RFP# 2025-11

Automatic Passenger Counters and Automatic Vehicle Location Systems

ADDENDUM # 2

Date of Addendum: July 16th, 2025

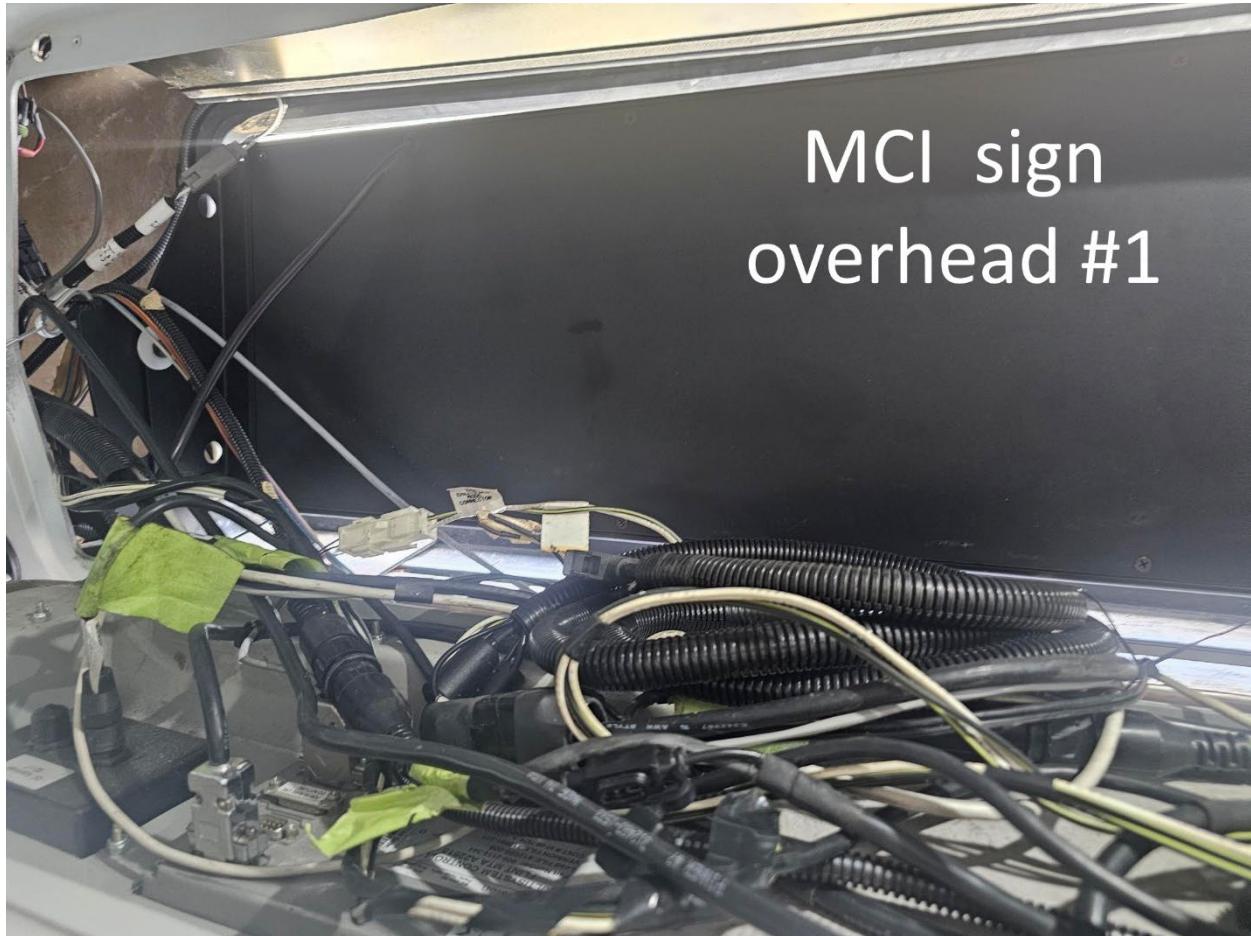
16. Do the trolleys have more than one driver station? Are the bidirectional?

Answer: Trolley's only have one driver station and travel one direction.

MCI Interior overhead #1

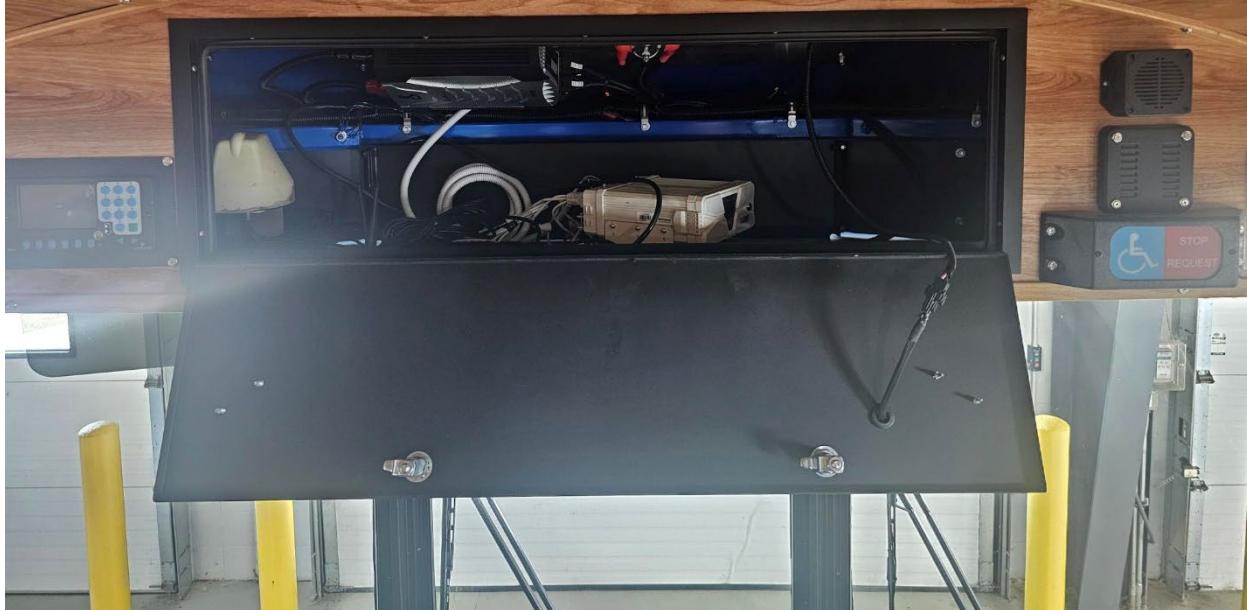
17. Can MTA provide a picture of the electric cabinets on the Bluebirds and MCI buses?

Answer: Yes. Please see the below for pictures of electrical cabinets as requested.
